ADDENDUM NO. 2

FEBRUARY 28, 2024

Staunton City Public Schools, VA
Shelburne Middle School Additions and Renovations
CRA Project No. 3636

ADDITIONS AND RENOVATIONS
SHELburne MIDDLE SCHOOL
SCHOOL BOARD OF THE CITY OF STAUNTON, VA
300 GRUBERT AVENUE, STAUNTON, VIRGINIA

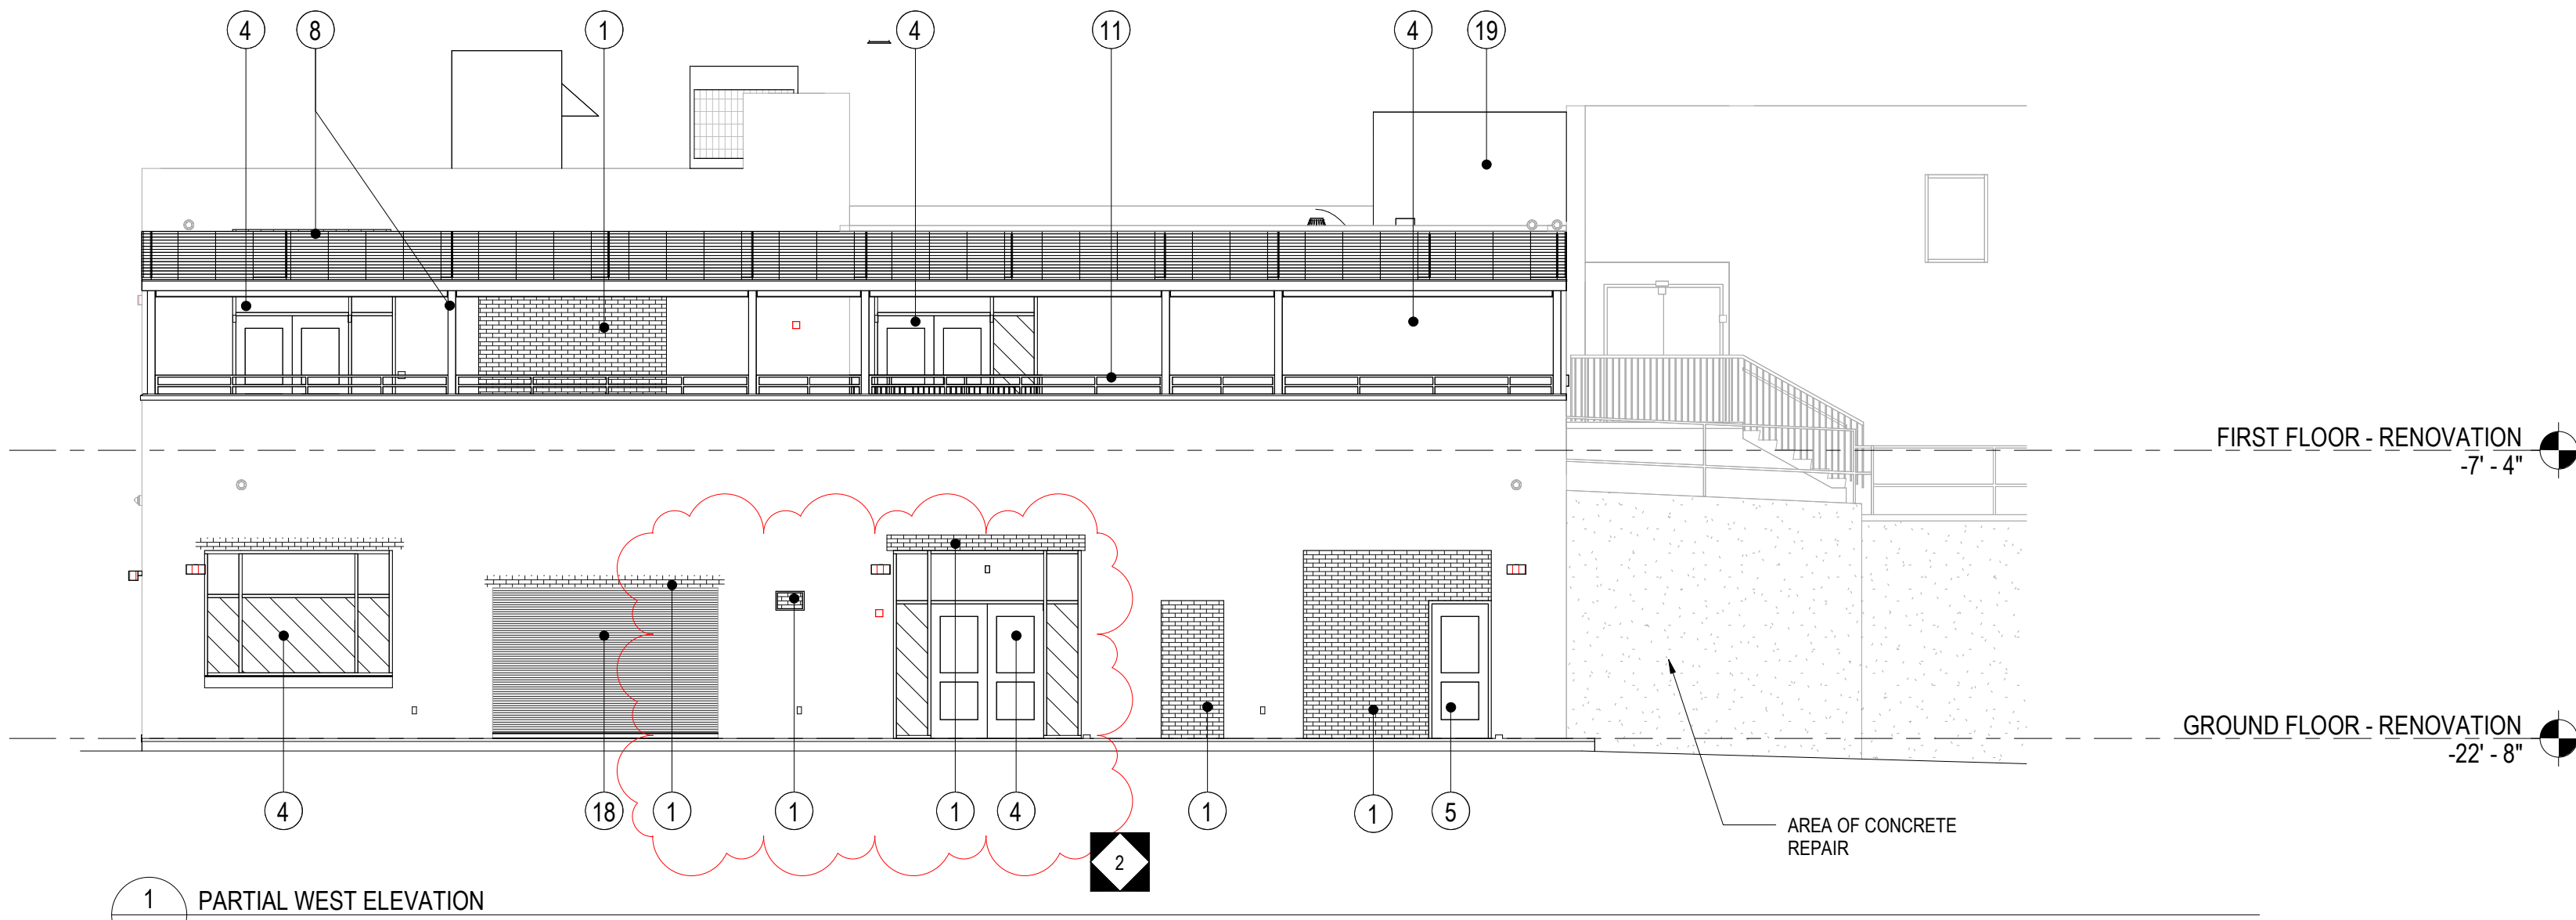
1. **DELETE** this sheet in its entirety and **REPLACE** with the attached sheet.
 - a. **REVISED** Telescopic Platform and seating layout.

A3.4

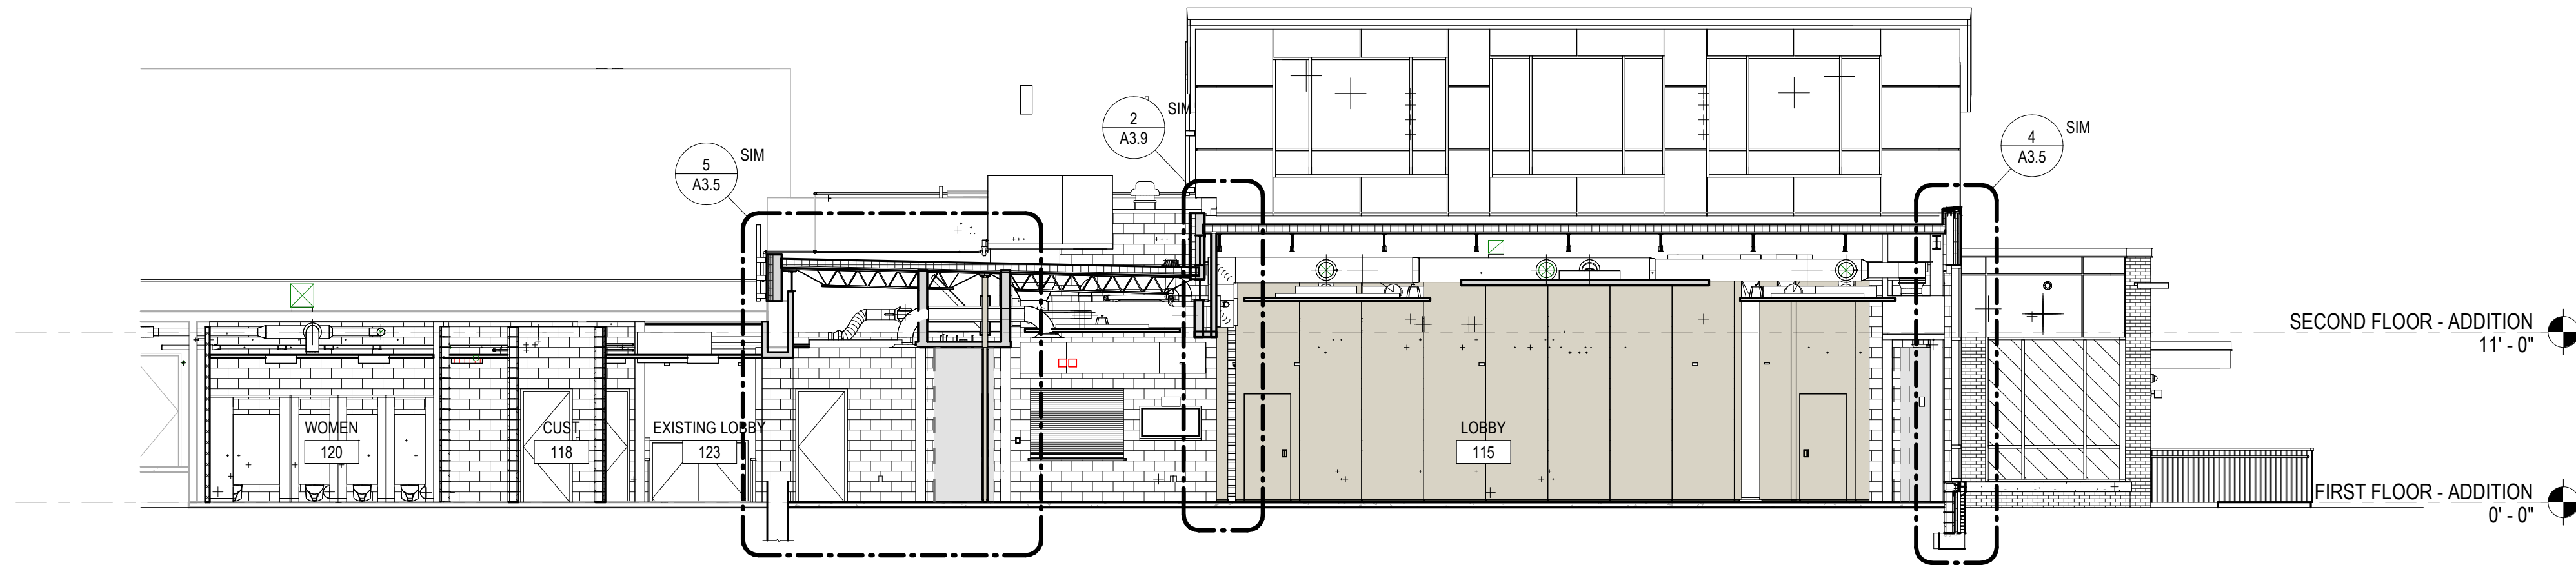
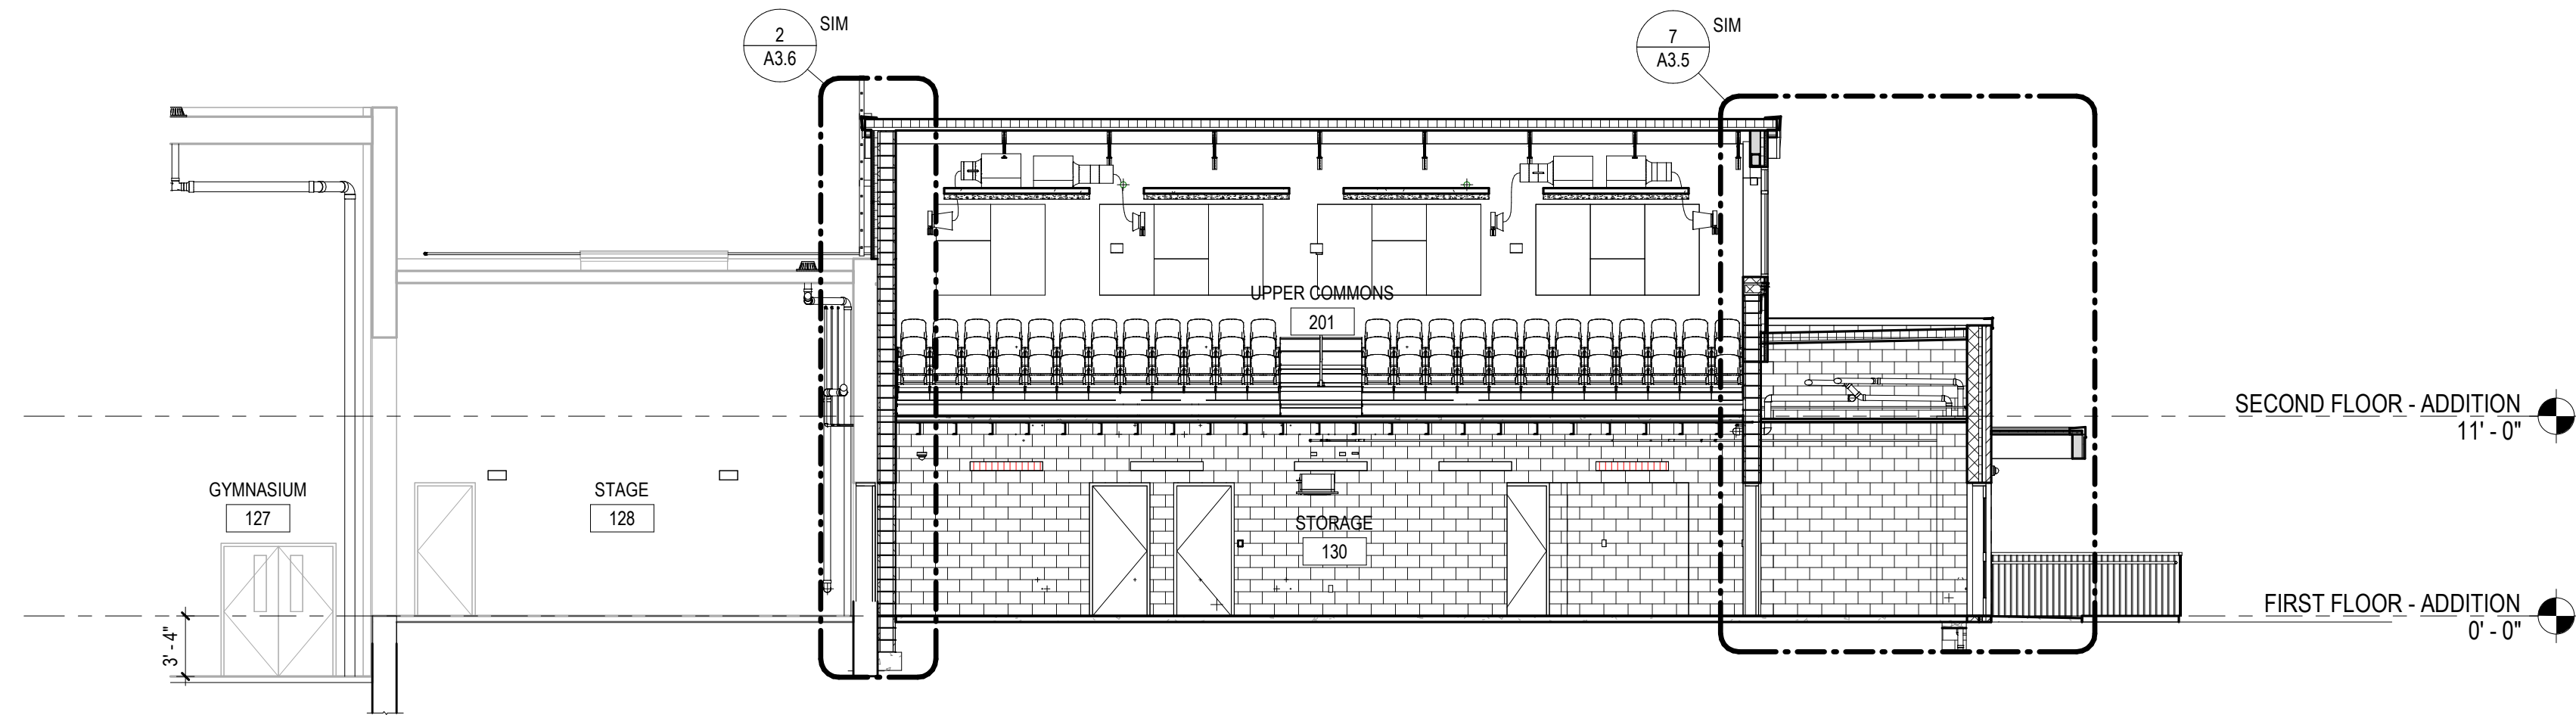
1. **DELETE** this sheet in its entirety and **REPLACE** with the attached sheet.
 - a. **REVISED** graphics identifying Telescopic Platform and Seating system.
